M E M O R A N D U M

March 16, 2021

SUBJECT: Shady Grove Sector Plan Minor Master Plan Amendment—transportation elements and fiscal impact statement¹

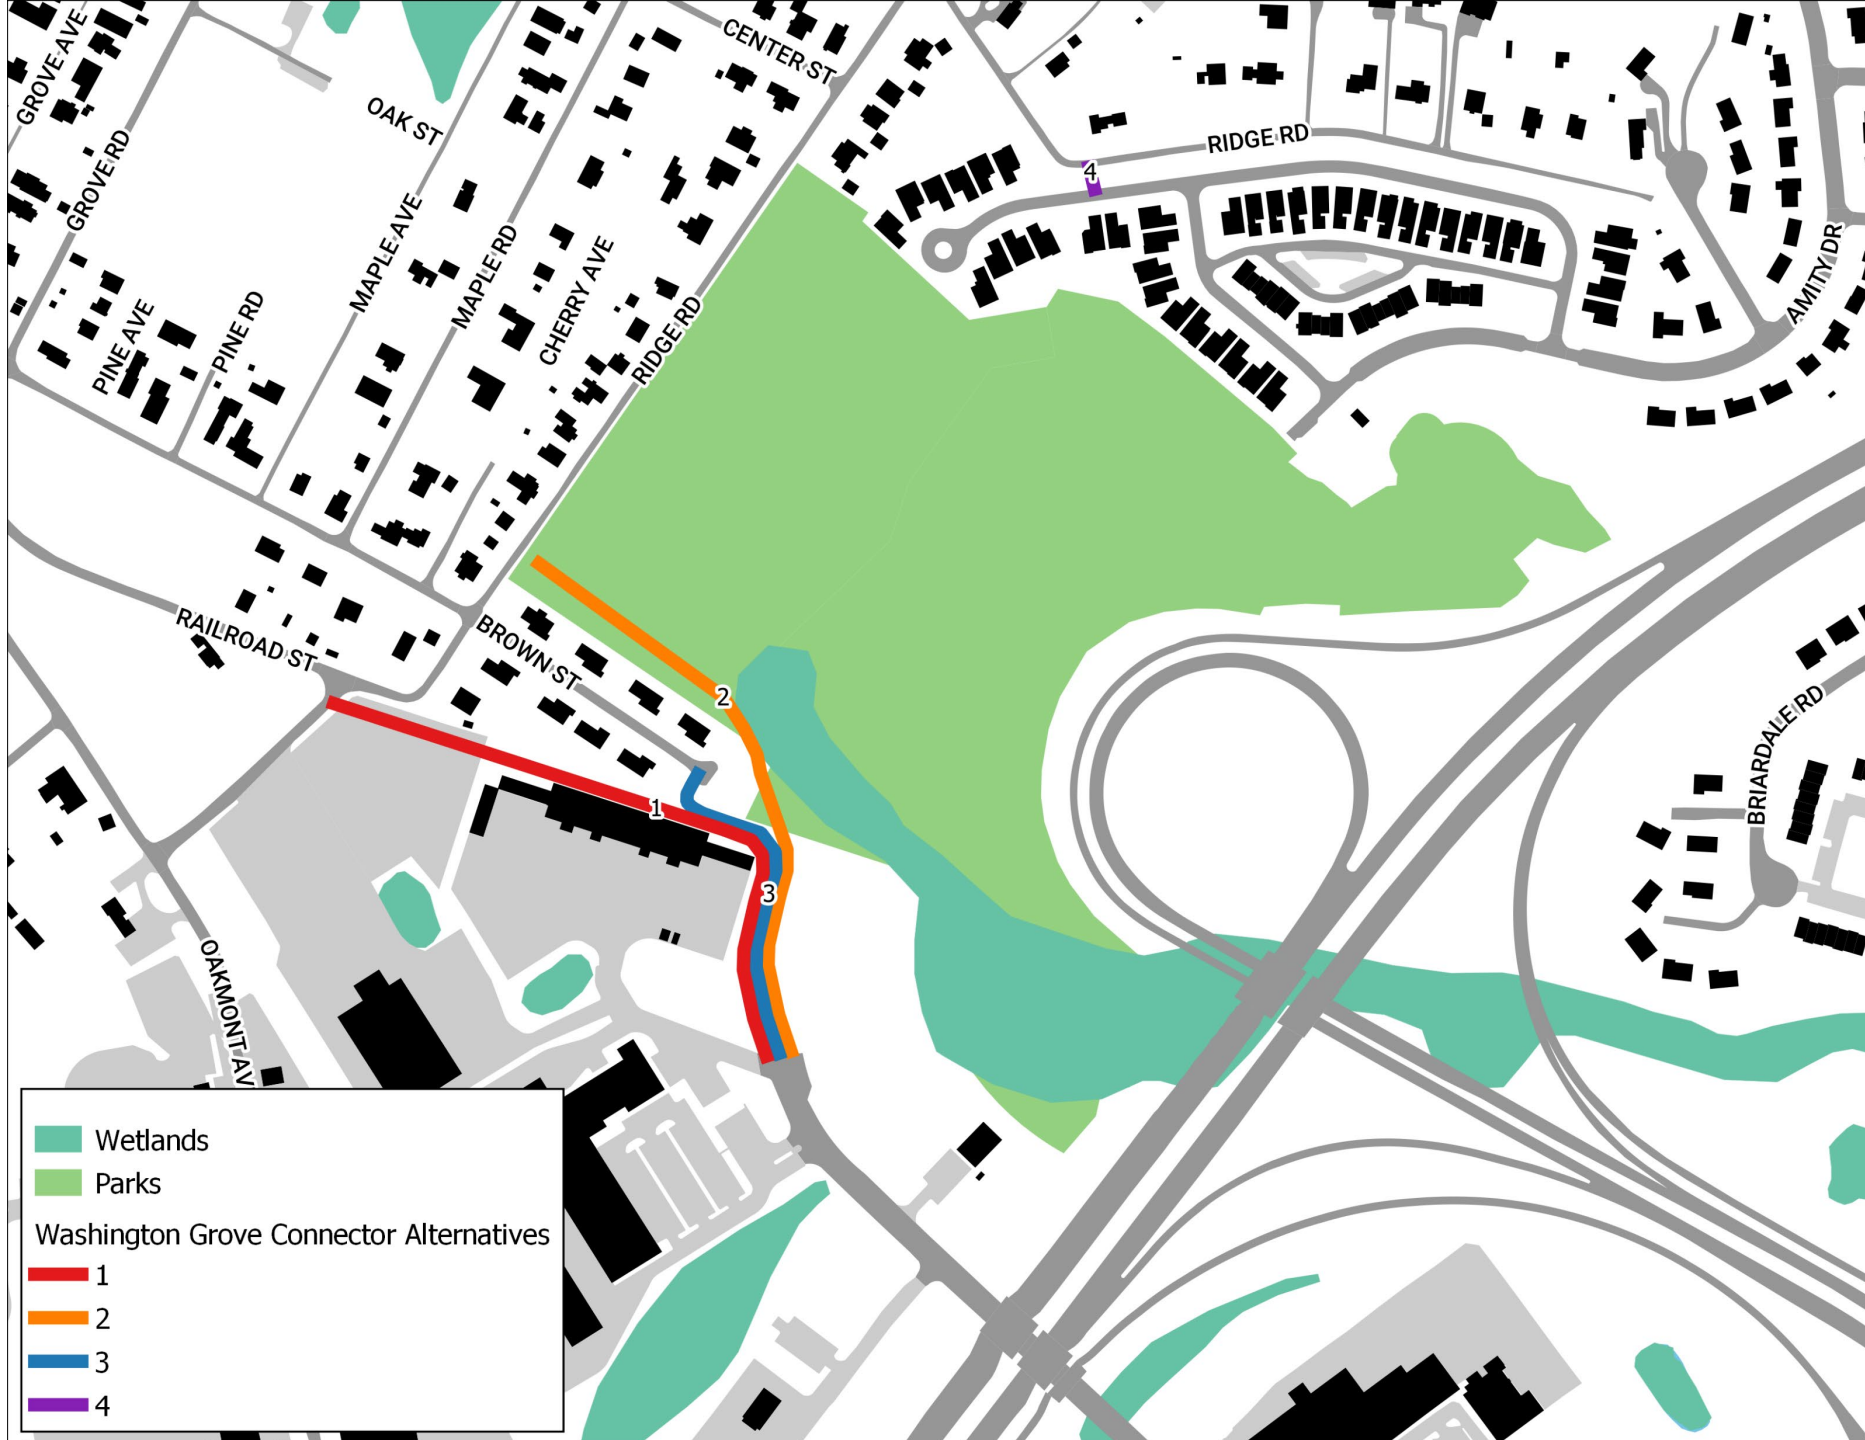
In summary, for the link between Washington Grove and Crabbs Branch Way, it is clear that the Brown Street Option is the best. Safety and attractiveness, the annexation agreement, and cost factors all support this choice. There are no known objective data weighing against it.

Linking of Crabbs Branch Way and Amity Drive should be done through a shared use path, not a road.

We would also like to add a point about the width of the path that will be built. A 12-foot wide path is the better choice. Many people on shared use paths are not familiar with the rule "stay to the right unless you are passing," and wander over towards the wrong side. When trail users are being passed, sometimes they don't hear or understand the purpose of the audible warning, so it is important to make sure the person passing can allow for a wide berth. And the path will be used by families with young children, who are often unpredictable on a path. Their safety must be protected.

Trail Alternatives

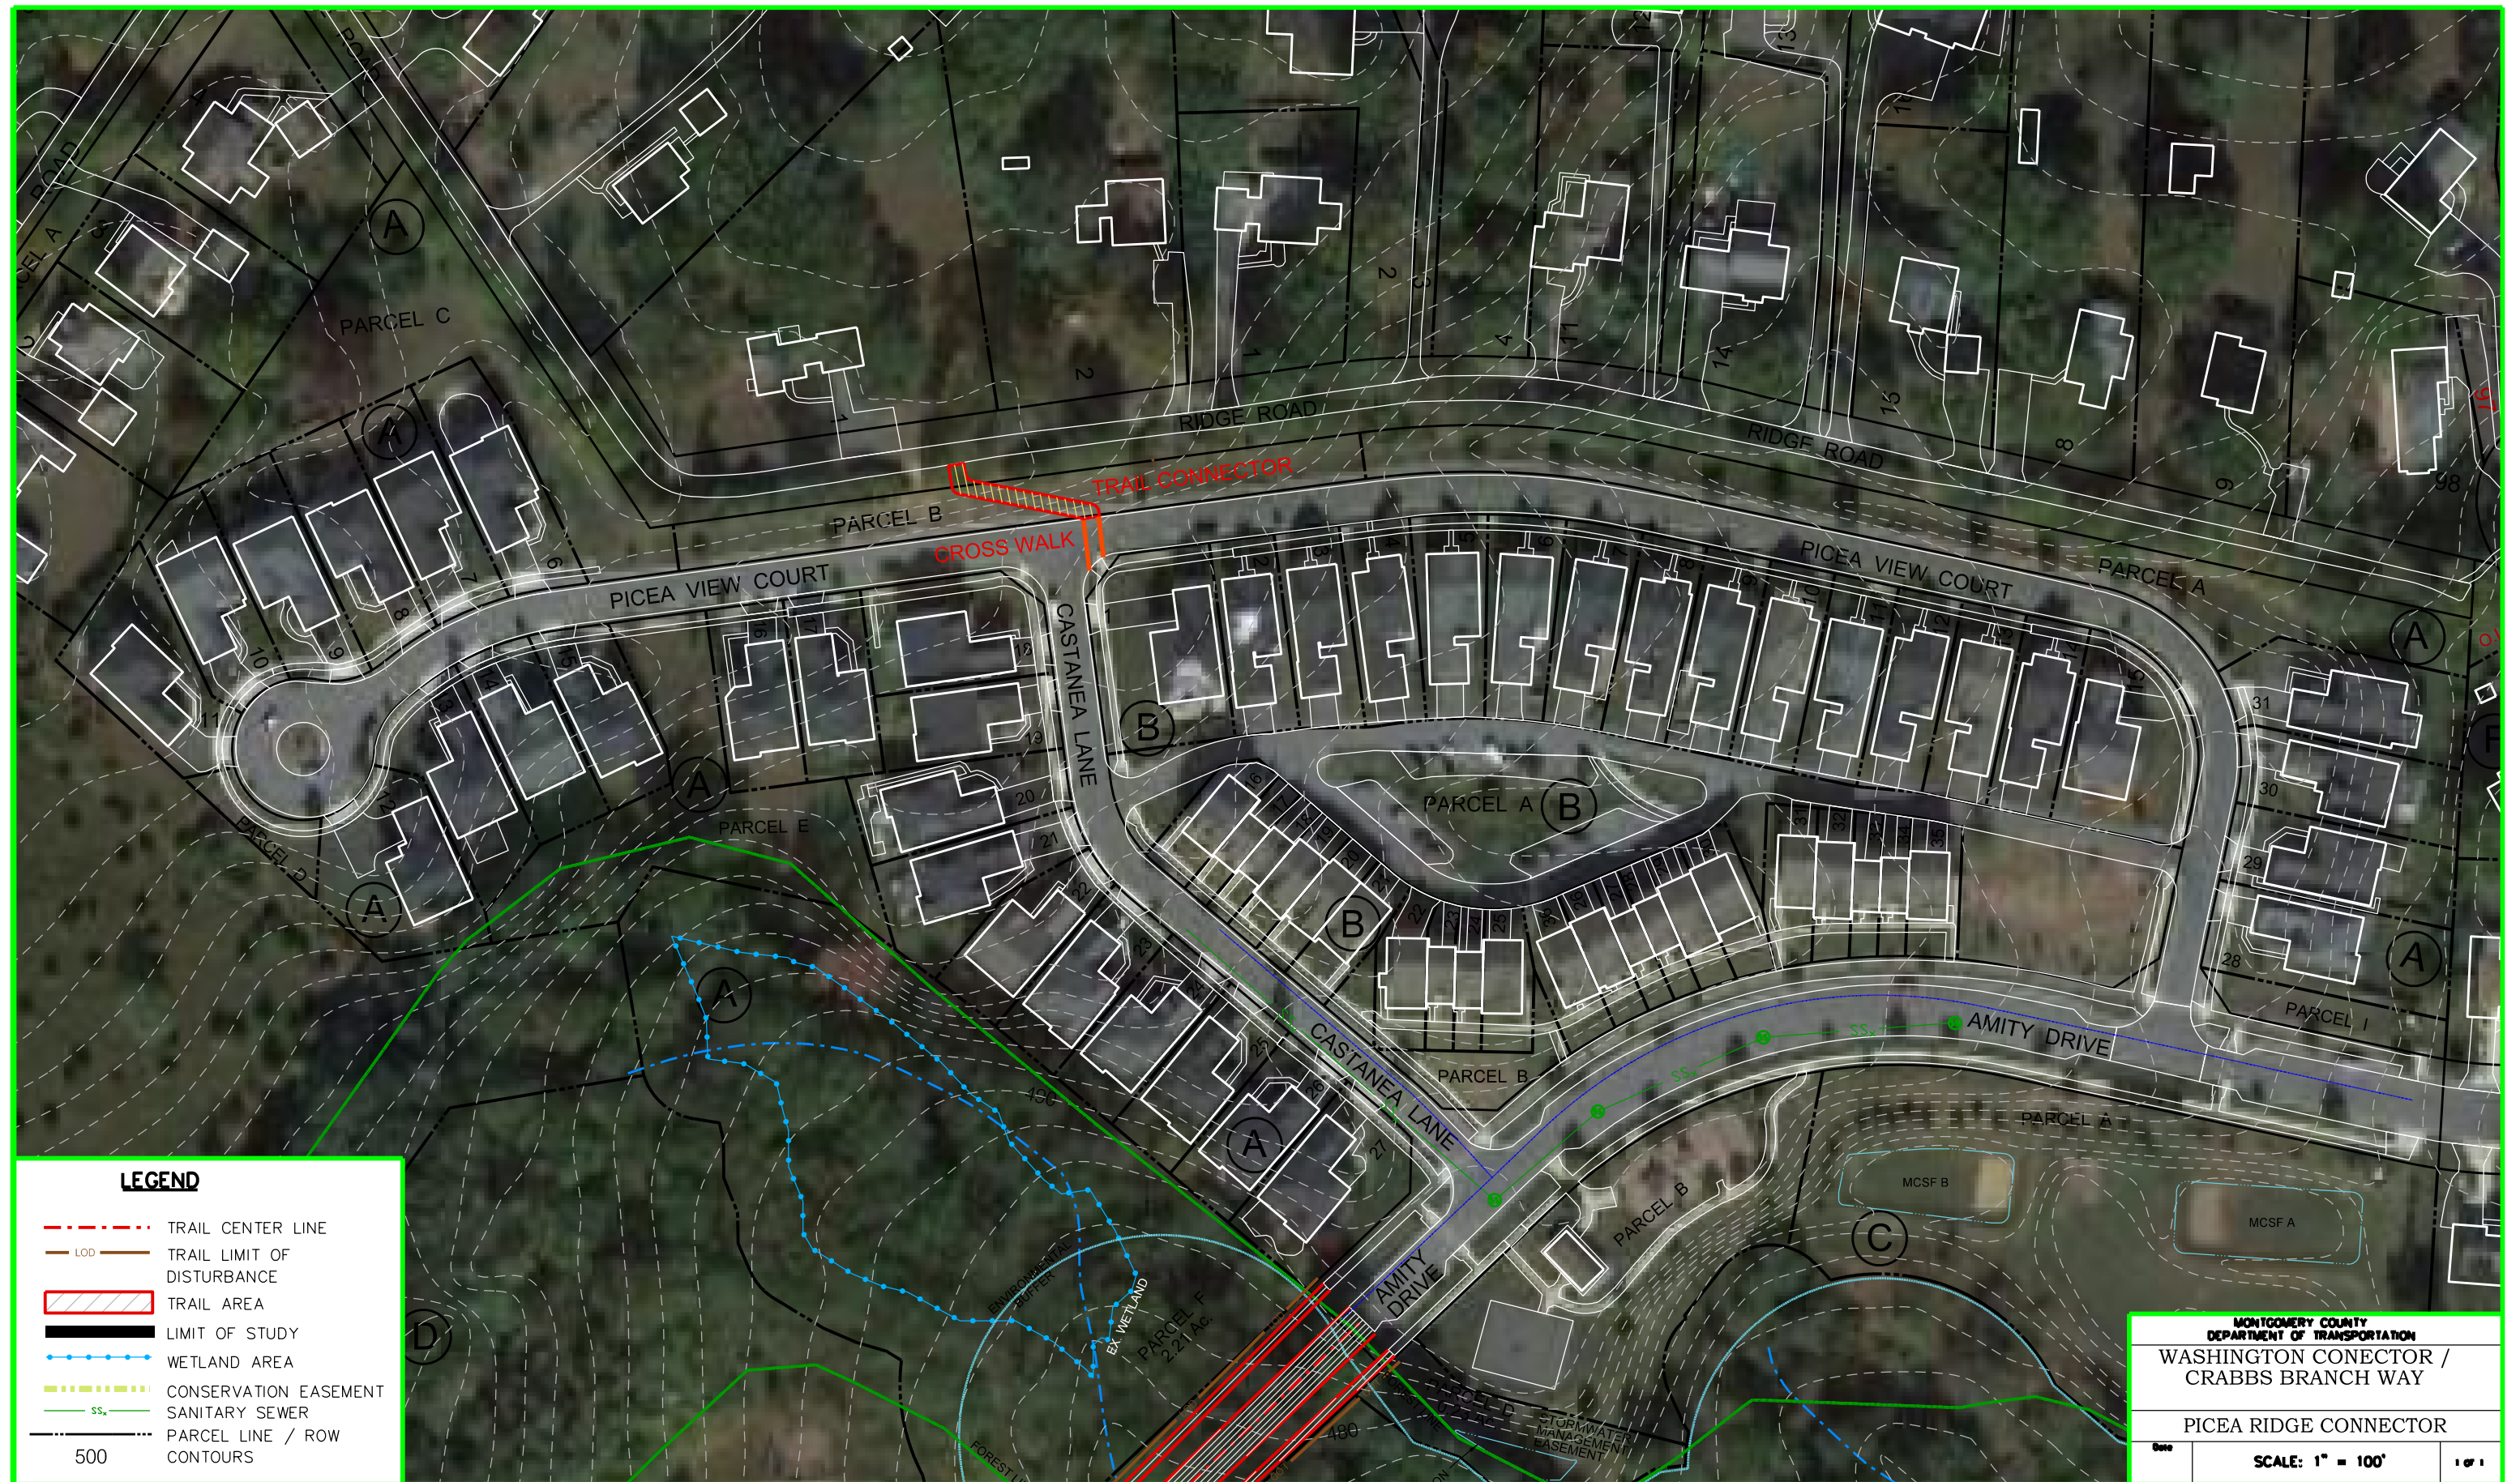
Mayor Compton and some residents of the Town of Washington Grove have raised concerns about the Sector Plan's depiction of a planned shared use path connection between the Town and the master-planned connection of Crabbs Branch Way/Amity Drive. Current master plans (most recently, the 2018 Bicycle Master Plan) called for this path to connect to southern end of Brown Street. DOT is currently studying four different options for making this connection, one that does connect to Brown Street, but also three others that are nearby but do not use Brown Street (©22-26). Under the Bikeway Program – Minor Projects project in the Capital Improvements Program, the Council has prospectively set aside \$675,000 to design and construct the option ultimately selected; design is programmed for FY23 and construction in FY24. Mayor Compton (©27) and the residents have pointed out that it is premature for the Sector Plan to identify Brown Street as the location for this path.

The consternation stems from Table 4, also on p. 131, which identifies how the Sector Plan would amend the 2018 Bicycle Master Plan. One of the lines in that table shows a sidepath along the east side of Oakmont Avenue from Shady Grove Road to Central Avenue (the “humpback” bridge) and has the note “Focus on Safer Parallel Connection at Brown Street.”

However, a closer inspection of the title of Table 4 reveals the following statement: “This Sector Plan recommends *the removal* of the following bikeways from the 2018 Bicycle Master Plan” (*emphasis mine*). Therefore, Table 4 is acknowledging that the references to an Oakmont Avenue path and to a focus on Brown Street would be replaced by the Piedmont Crossing Local Park Trail in Table 3. **Council staff concurs with Map 52 and Tables 3 and 4 in the Final Draft.**
